November 5, 2012

**RE: GOODYEAR RIVERWALK
SEIBERLING STREET LANDFILL
SEIBERLING WAY
NOTICE OF VIOLATION**

This letter provides a notice of violations and comments as identified during a recent inspection conducted by the Ohio Environmental Protection Agency (Ohio EPA). On October 30, 2012, Ohio EPA inspected the Seiberling Way road construction at Seiberling Street Landfill. The inspection included the roadway excavation through waste, waste mound, and storm water controls. The construction project has been authorized by Ohio EPA through a Director's Authorization and Exemption Order approved November 2011, pursuant to Ohio Administrative Code (OAC) 3745-27-13 (November 2011 Rule 13).

Attachment: Section of storm and sanitary sewer plan drawing dated 1982

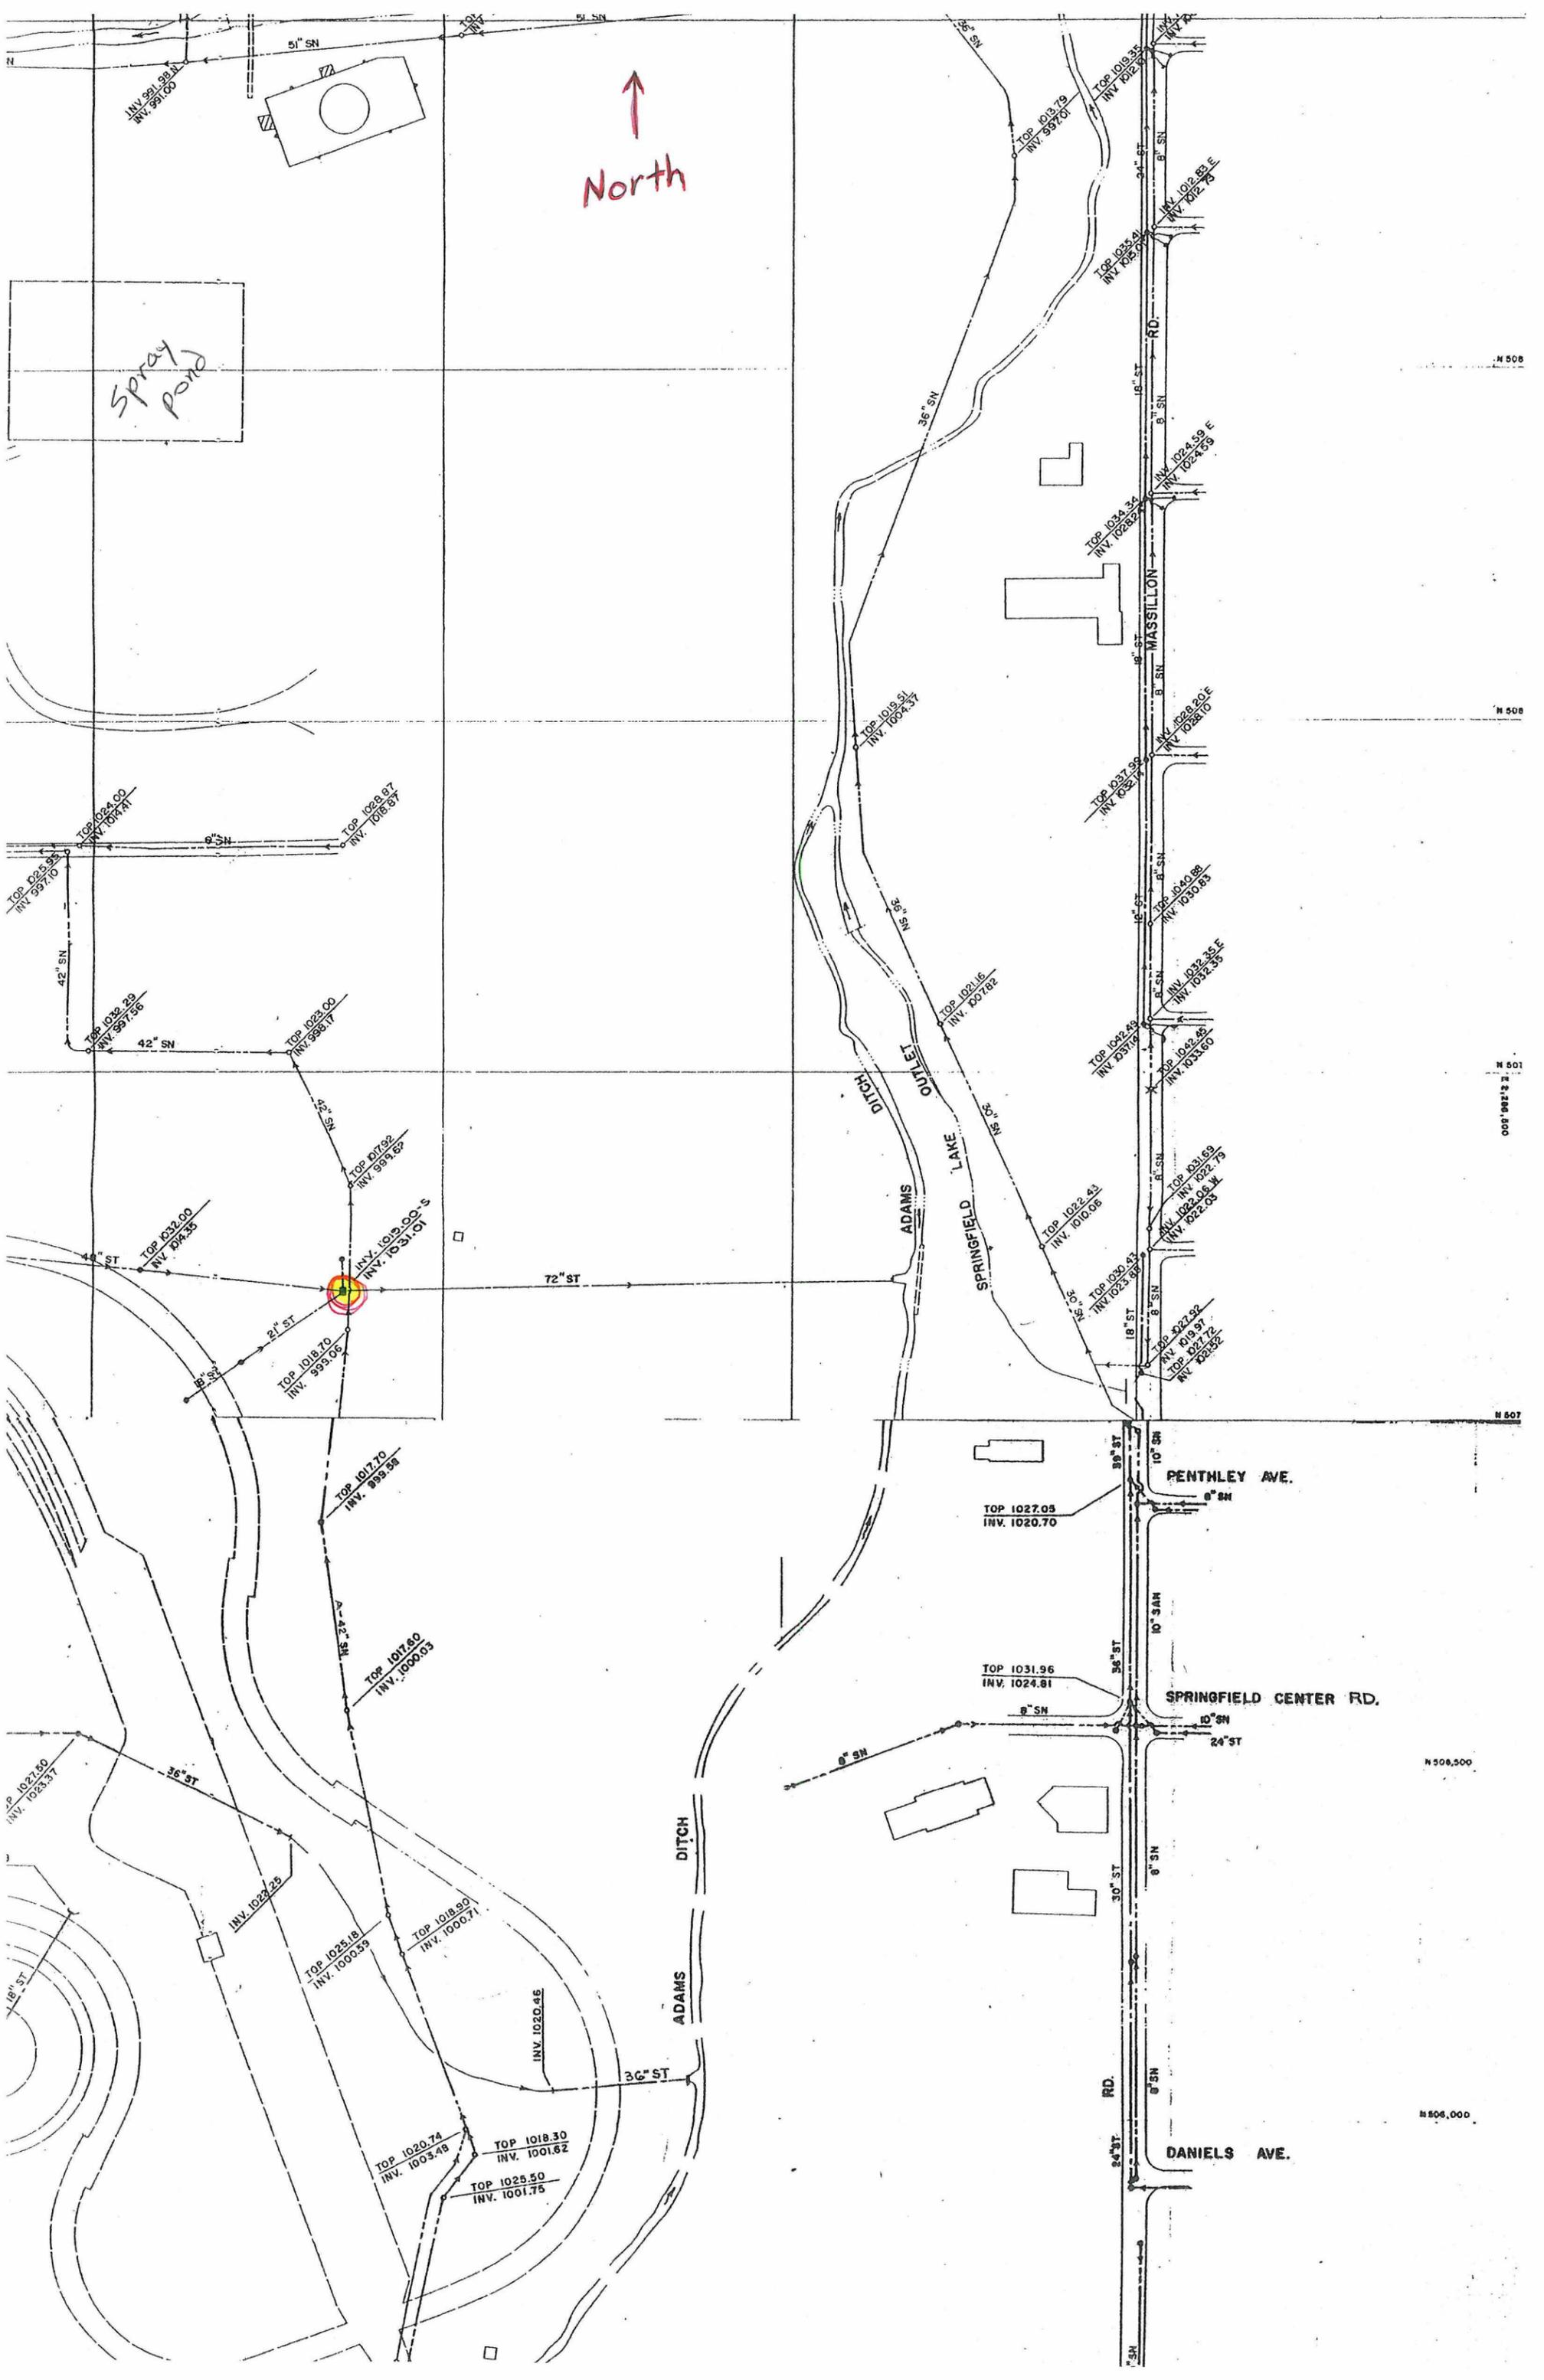
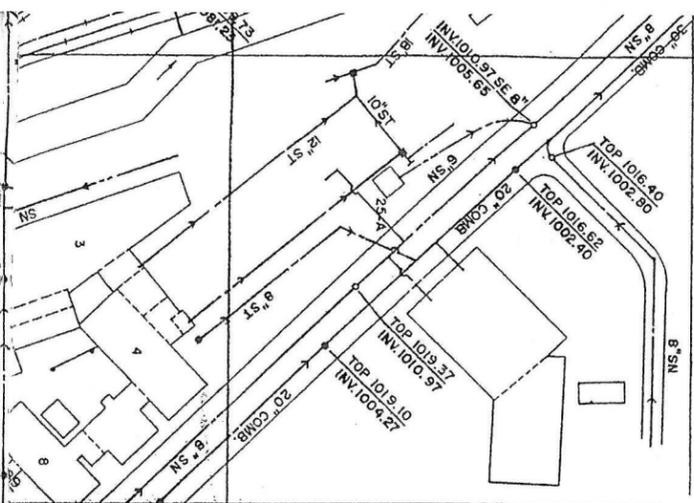
There were three unidentified manhole-like structures that were found during excavation of the roadway. It is unclear if these structures are storm sewers, dry wells, sanitary sewers, injection wells, etc. Please provide information on the unidentified structures, such as depth, type of sewer or well, possible tie-ins with other sewers. Please submit a proposed alteration to Exhibit 1 of the November 2011 Rule 13 authorization in accordance with Section VII of the authorization order. The proposed alteration shall include details as to how these three structures will be abandoned, including the following information: Excavated materials shall be replaced with low strength mortar grout or bentonite clay, any water collected from these structures should be considered leachate and should be properly

characterized and disposed of in accordance with ORC Chapter 6111. Attached is a section of a plan drawing showing sewers in the landfill area from 1982 that may be helpful. On the drawing "ST" stands for storm sewer.
